## Addendum No. 001

Project: Blinn A & G  
Project No. 240566  
Date: 1/13/2025

Blinn Bldg A and G

BLINN BUILDINGS A & G

**1 MECHANICAL DEMOLITION PLAN - FIRST FLOOR - BUILDING G**  
 NORTH MD1.2 1/8" = 1.0'

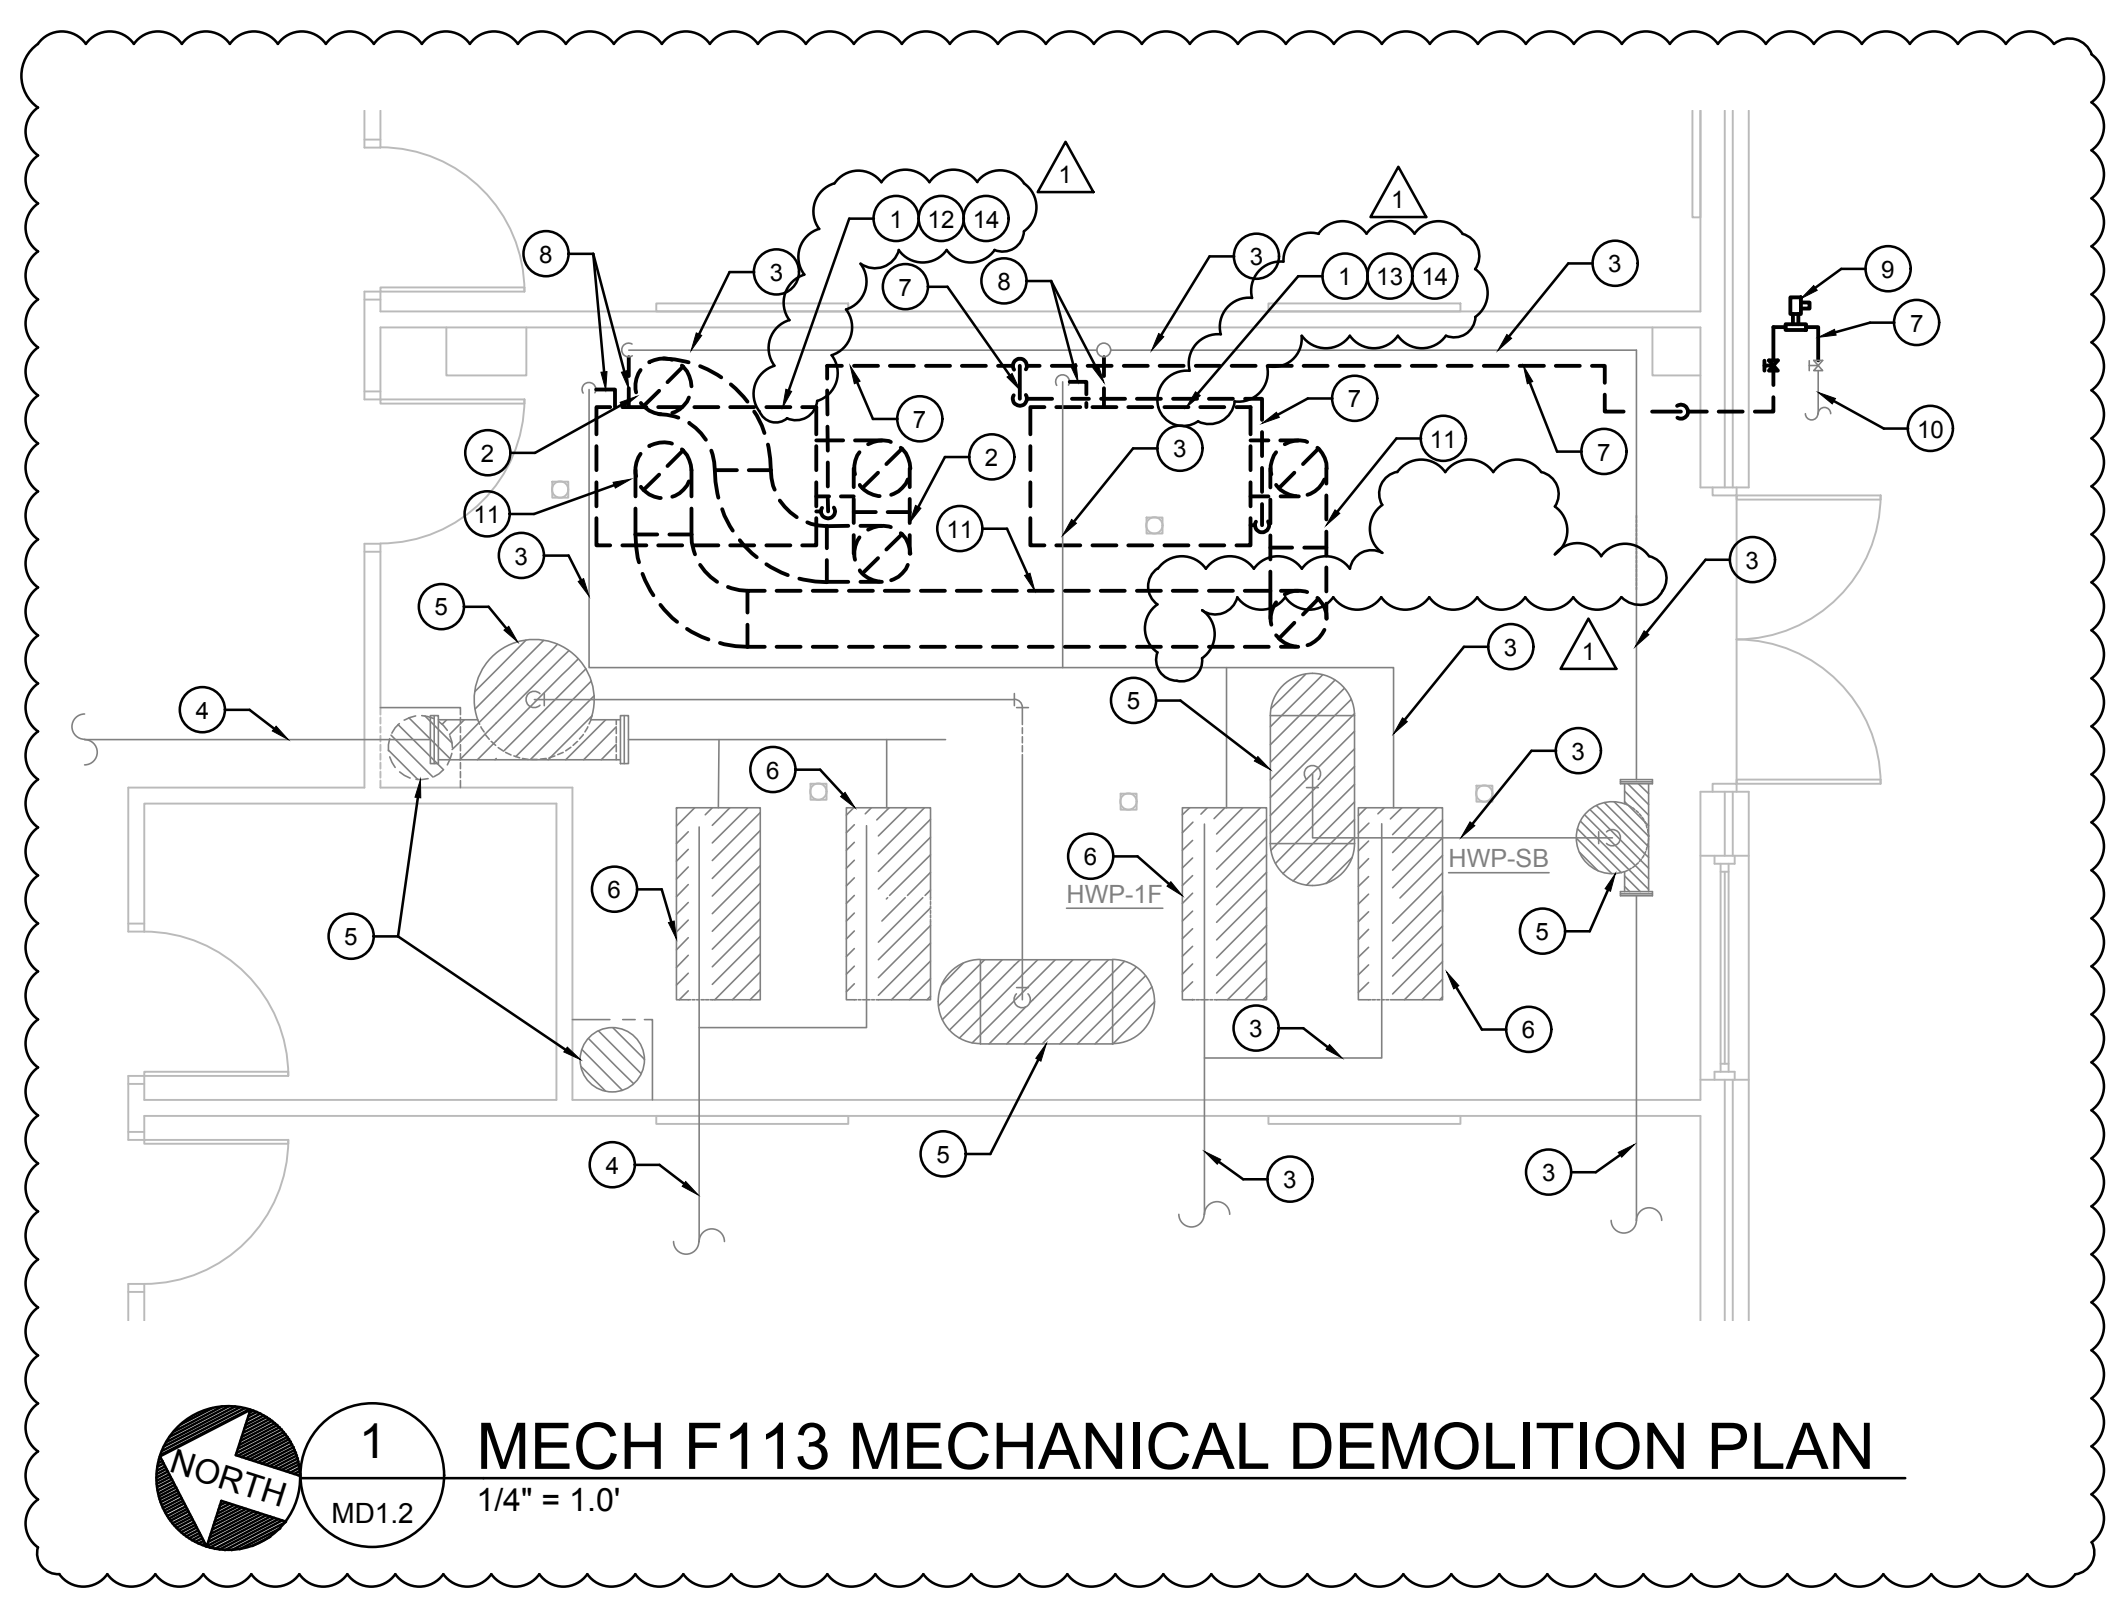
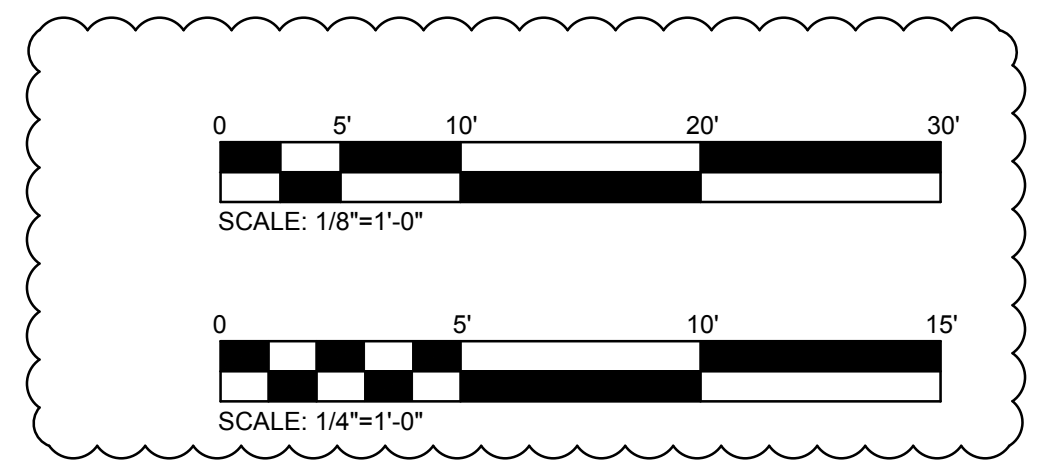
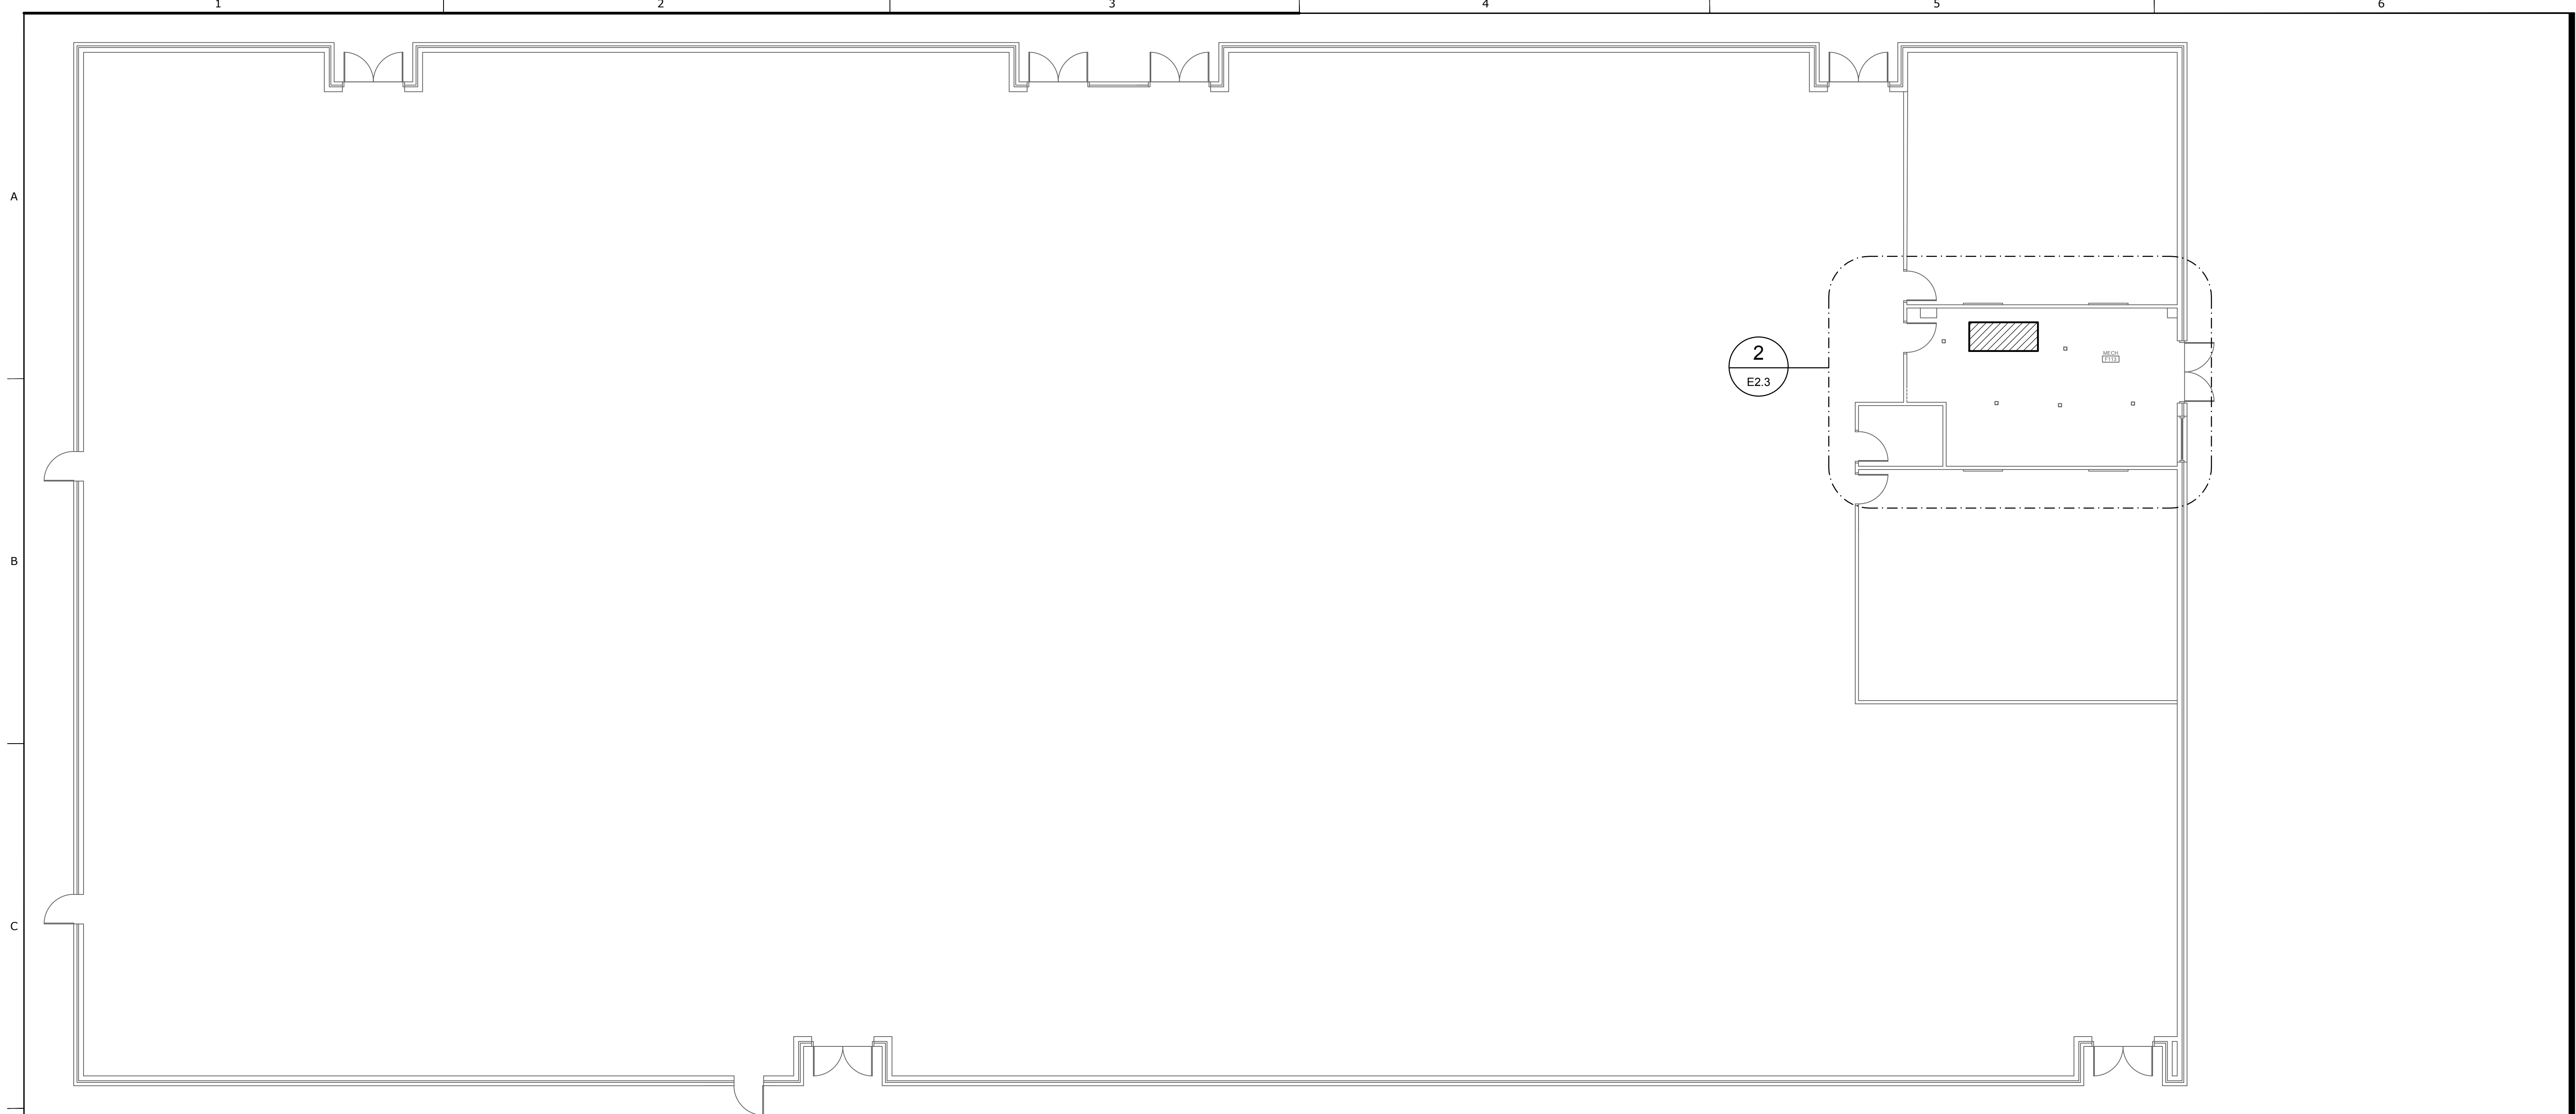
- a. Building G floorplan has been added.
  - b. Enlarged floorplan of Mech F113 has been added.
  - c. Demolition keyed note 12 has been modified.
  - d. Demolition keyed note 13 has been added.

- e. Demolition keyed note 14 has been added.
  - f. HW bypass loop was removed from demolition plan.
  - g. 1/4" Scale bar has been added.
  - h. 1/8" scale bar has been moved.

**1** ELECTRICAL NEW WORK PLAN - FIRST FLOOR - BUILDING G  
E2.3 1/8" = 1.0'

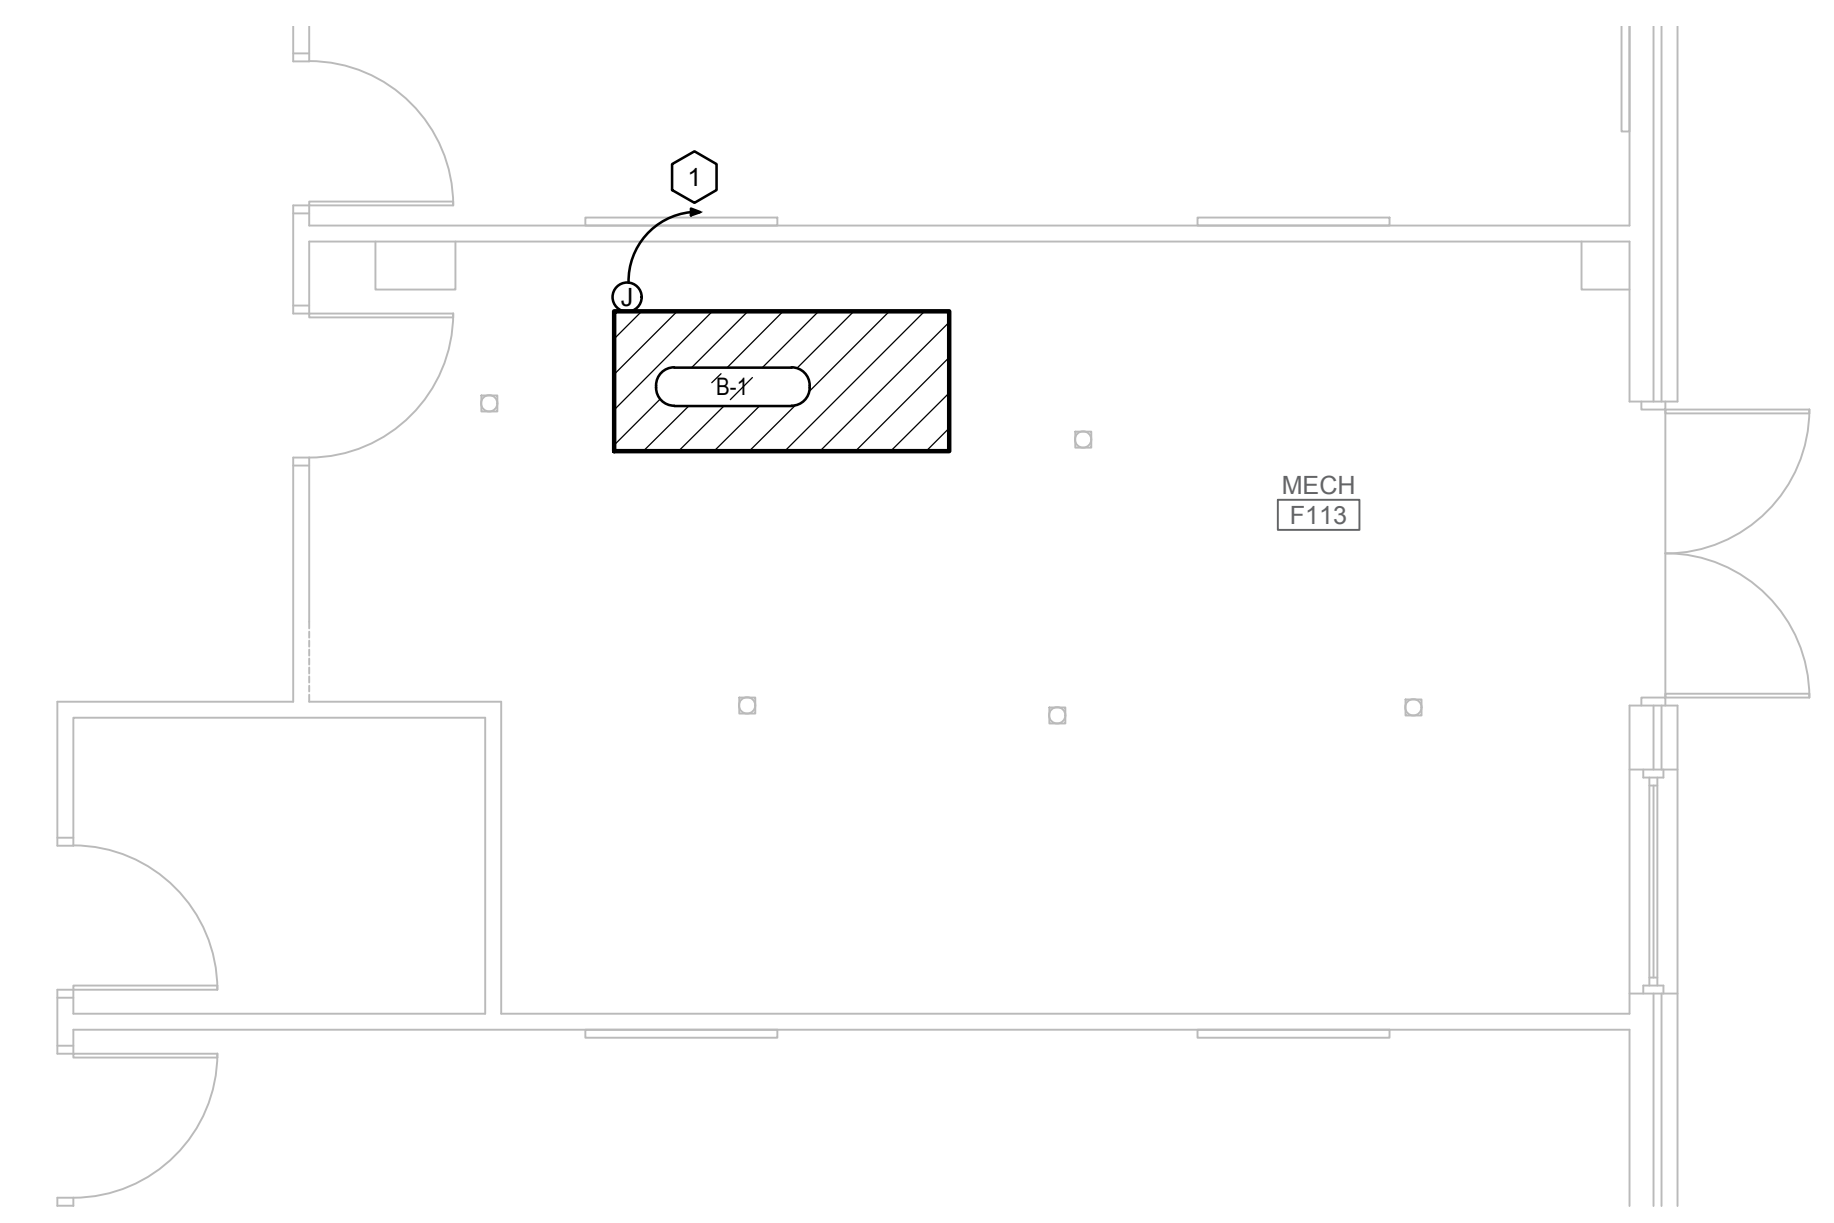
1. Sheet E2.3 – ELECTRICAL NEW WORK PLAN – FIRST FLOOR – BUILDING G
  - a. New sheet.
